UNITED STATES PATENT AND TRADEMARK OFFICE

APPLICATION NO.	FILING DATE	FIRST NAMED INVENTOR	ATTORNEY DOCKET NO.	CONFIRMATION NO.
09/847,901	05/02/2001	Masajiro Inoue	SIW-008	7510
959 75	590 10/06/2003		EXAMINER	
LAHIVE & COCKFIELD 28 STATE STREET			ALEJANDRO, RAYMOND	
BOSTON, MA 02109			ART UNIT	PAPER NUMBER
			1745	* -

DETAILED ACTION

FIG. 3

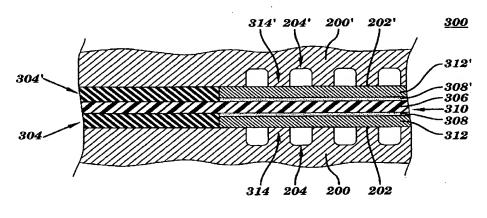
As seen in Figure 3, fuel cell 300 includes the membrane electrode assembly (MEA) 310 comprising a solid polymer electrolyte 306, catalyst 308 and 308' which facilitate chemical reaction are applied to the anode and cathode sides, respectively of the solid polymer electrolyte. This unit can be referred to as a membrane electrode assembly (col 6, line 56 to col 7, line 4). The MEA is sandwiched between anode and cathode gas diffusion layers 312 and 312', respectively (col 7, lines 5-8).

For purposes of illustration, Figure 3 also depicts the fuel cell with fluid flow plates 200 and 200' serving as flow field plates (it is noted that separator plates are sometimes referred to as flow field plates, that is, separator plates are also conventionally known in the art as flow field plate), in particular, flow field plate 200 might serve as an anode side of the fuel cell, and flow field plate 200' might serve as a cathode side of the fuel cell. That is, face 202 might comprise an anode face, and face 202' might comprise a cathode face (col 6, lines 44-50).

Jones discloses that gasketing material or gaskets 304, 304' can be employed to seal peripheral holes. A given gasket might take the form of, for instance, a frame gasket made from polytetrafluoroethylene material (col 6, lines 34-42). As depicted in Figure 3, the gasketing material 304, 304' contacts the end faces of both gas diffusion layers 312 and 312'.

As illustrated in Figure 3, the edge of solid polymer membrane 306 extends beyond (extended/projecting portion) the end faces of the anode and cathode side; and the gasketing material 304, 304' contacts the extended portion of the solid polymer electrolyte.

As depicted in Figure 3, the gasketing material 304, 304' contacts the end faces of both gas diffusion layers 312 and 312'.

As shown in Figure 3, the gasketing material 304, 304' contacts the end faces of both gas diffusion layers 312-catalyst 308 and gas diffusion layers 312'-catalyst 308' which are considered to be the anode and cathode electrode sides, respectively.
